SERVICE BULLETIN

No. 522

Piper Aircraft Corporation

Wing Fuel Tank Cap Modification.

VIEW OF FUEL TANK CAP - P/N 15296-02

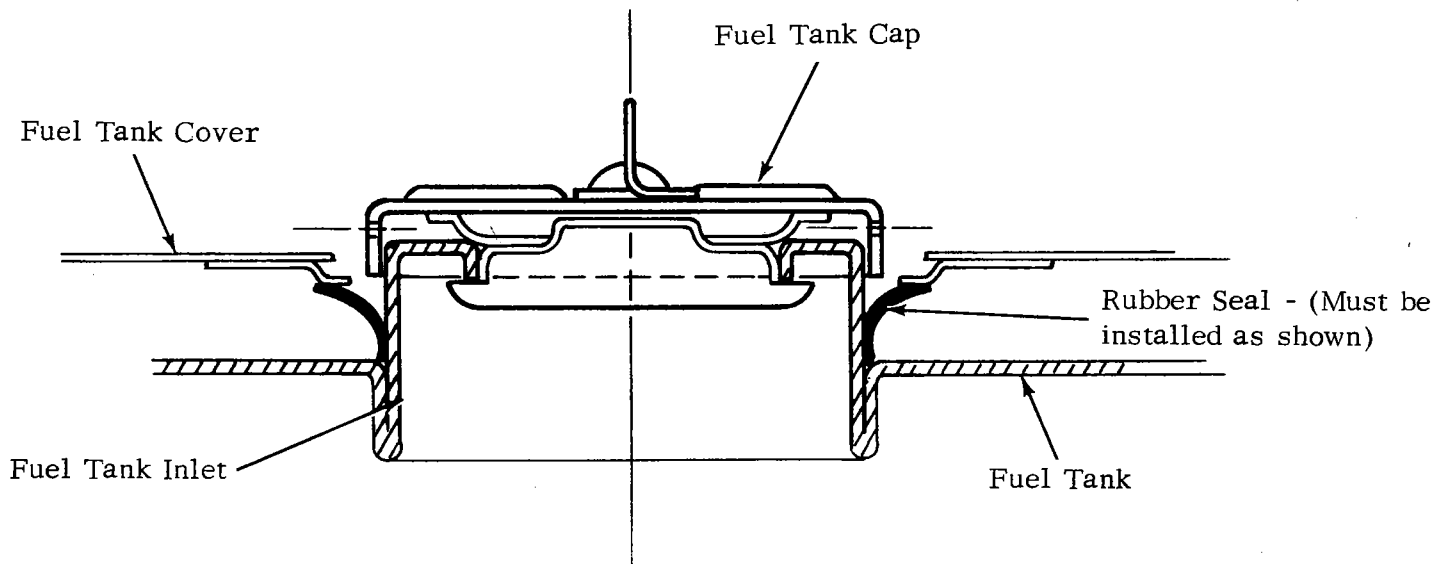
Two reports have been received from the field describing collapsed wing mounted fuel tanks, resulting from inadequate venting of the tank. This condition can occur when the fuel tank filler neck gasket is inverted, thus creating a seal between the filler neck and the fuel tank cap, Piper part number 15296-02.

This service release provides instructions to apply additional vent holes in the fuel tank cap to allow continued positive fuel tank venting in the event that the tank filler neck gasket inadvertently develops a seal between the filler neck and the fuel tank cap. The attached sketch illustrates the above referenced fuel tank cap modification and proper installation of the fuel tank filler neck gasket.

1. Remove fuel tank caps from wings and rework caps by drilling two .062 holes .16 down from top of cap. Holes must be aligned with vent slots as shown.
2. Inspect rubber seal around fuel tank inlet to determine if seal is properly installed as shown.
 - a. If seal is not installed correctly, remove fuel tank cover from wing, reposition seal as shown and reinstall fuel tank cover.
3. Reinstall reworked fuel tank caps and make proper logbook entry of Service Bulletin 522 compliance.
